Change Description

M7100 800 MHz – RU102917V1 (Data Unit)

The following provides a description of the M7100 800 MHz Data unit, (RU102917V1) and how it differs from the standard M7100 800 MHz, (RU101188V131).

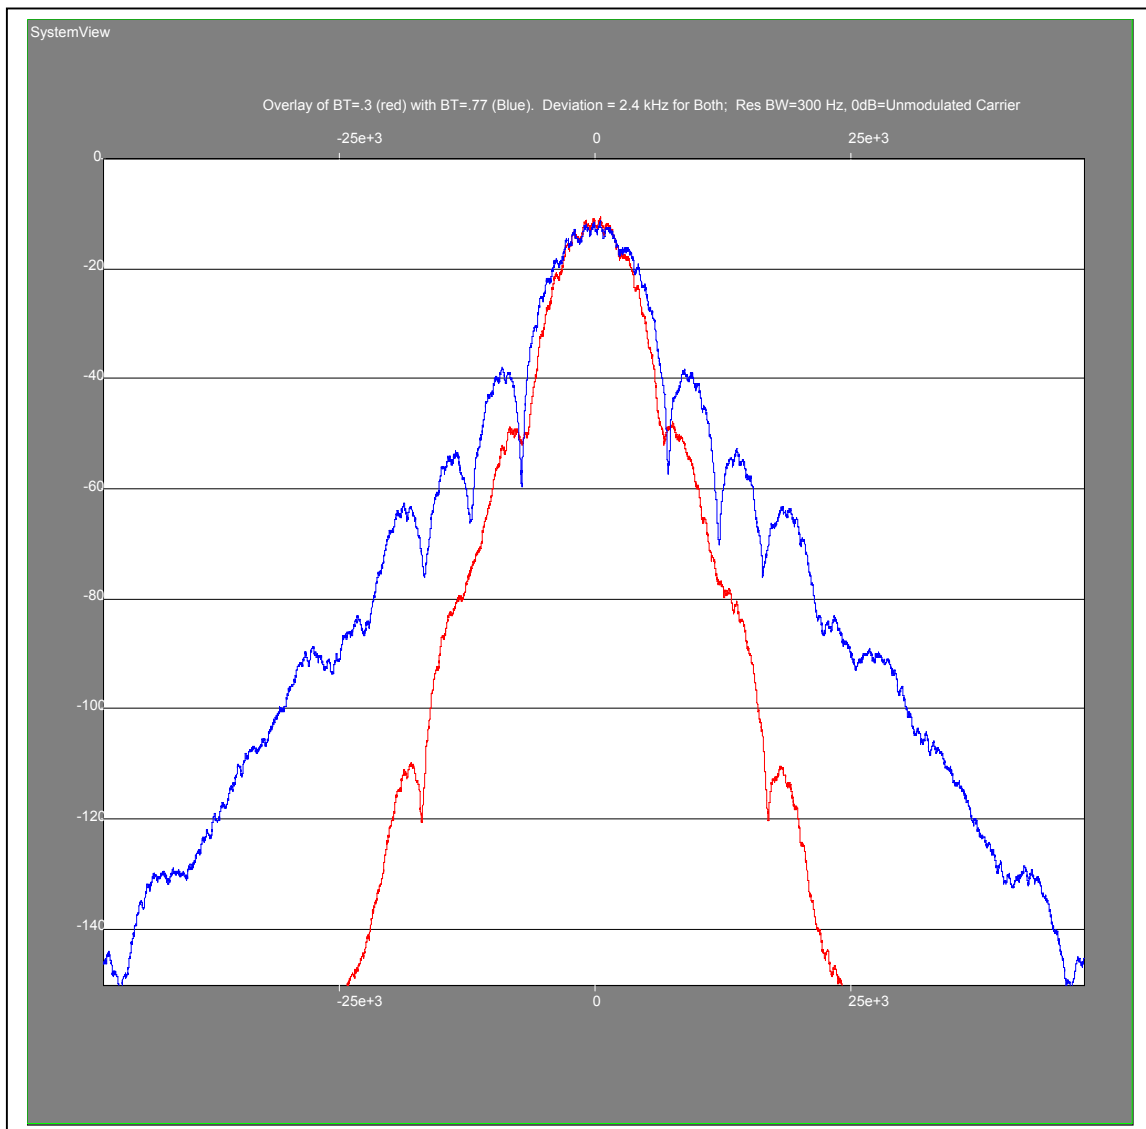
The RU102917V1 model has been designed to be used with an external modulation signal source with the following characteristics: 2-level Gaussian FSK, 9600 bits per second and BT = .3. The deviation will be set for +/- 2.4 kHz peak deviation.

Please see the following modeled plot overlay, which shows spectrum for the new RU102917V1 with BT = .3, as compared to the standard M7100 800 MHz, RU101188V131.

Model characteristics are:

- Overlay of BT=.3 (red, narrow) with BT=.77 (blue, wider)
 - BT = .3 (red) = External Modulation Source to be used with new RU102917V1
 - BT = .77 (blue) = Modulation source used with the original RU101188V131.
- Deviation = 2.4 kHz for both
- Res BW=300 Hz
- 0dB=Unmodulated Carrier
- No phase noise assumed

Figure 1 – Schematic of plug-in board added to standard radio:

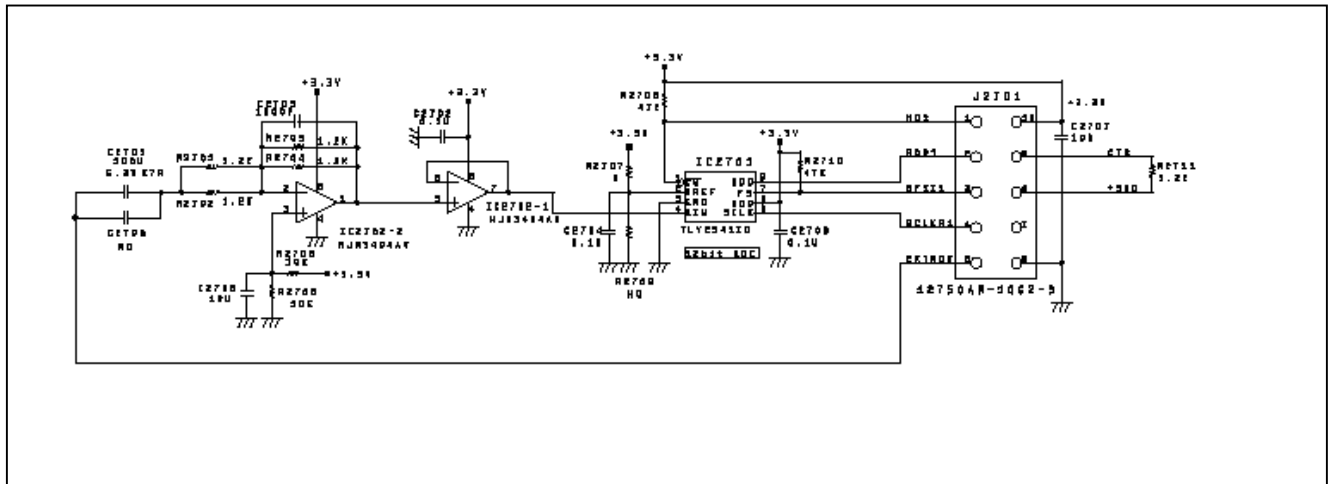
The EXTMOD input to the M7100 (RU102917V1) connects through pin 32 on the ORCC (enclosure connector) to an Analog to Digital Converter (ADC). This ADC is controlled by the DSP, which processes the incoming signals and routes to the modulator. The EXTMOD input has been added with this change.

The input circuit to the ADC is band limited with a 10 kHz Low Pass Anti-aliasing Filter and is AC coupled.

Figure 2 – EXTMOD IN signal from add in board connector to the DSP function block:

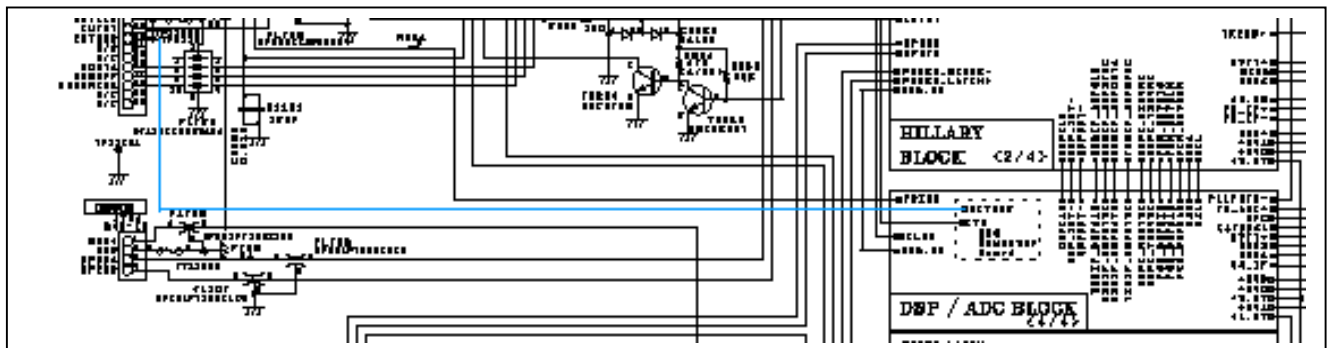
The modulation signal source will be external to the M7100 unit. A device external to the M7100 supplies a waveform through the M7100 EXTMOD Input (ORCC pin 32) and is routed through the DSP and out to the modulator, from IC713 in the same method as is done with the RU101188V131. The DSP performs limited filtering to reduce noise.
